DOOSAN **Document Transmittal** Upper Trishuli-1 HEP (216MW)	Date 2022-04-27	DT No.: UT1-HEP-DHI-PC-D-0024	SHEET 1 OF 1

DOOSAN NEPAL BRANCH OFFICE	Address & Contact No. : Four Square Building, Naxal, Kathmandu, Nepal (P.O Box : 1387) + 977 1 692 3014	Project No. H20002	DOCUMENT DISPATCHED BY Courier Service ☐ Messenger ☐ Post-Air Freight ☐ Document System or E-mail ■ By hand ■
DOCUMENT DISTRIBUTION	■ POWER CHINA (Subcontractor) ☐ Doosan's Site Office		
SUBJECT	Review Note RN-0114_Reinforcement Drawing of Inlet Structure of Diversion Tunnel

UPPER TRISHULI-1 HEP (216MW)			
Client	**Nepal Water and Energy Development Company Private Limited**		
Owner's Engineer	**Tractebel Engineering GmbH / Jade Consult**		
REVIEW NOTE			
Contractor	**Doosan Enerbility**		
Title of the Document	Reinforcement Drawing of Inlet Structure of Diversion Tunnel, sheets 1-4		
Document No.	UT1-C-010-CVL-DG-42004	Revision	0B
Date of Documents	14.04.2022	Received Date	19.04.2022
Transmittal Form No.	UT1-HEP-DHI-D-0207		
Previous Review Date/Status	26.03.2022/RR	Prev. Review Note No.	RN-0100
Review Note No.	**RN-0114**	**Present Review Date**	**26.04.2022**
		Present Review Status	**RR**

Comments to UT1-C-010-CVL-DG-42004, sheet 3 of 4

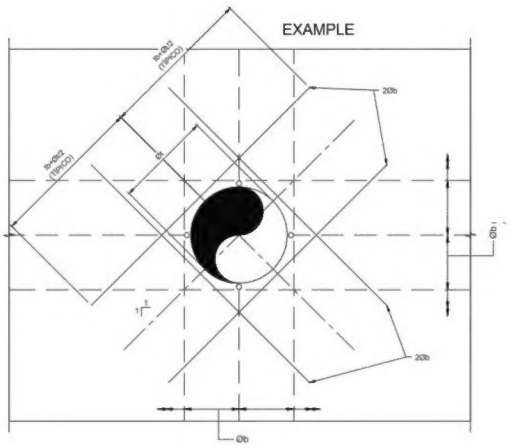
1. Details of air vent pipe reinforcing:
   Circular re-bar "type a" is not suitable as the air vent pipe is not pressurized under operation.
   An example as a standard detail is shown in the sketch below:
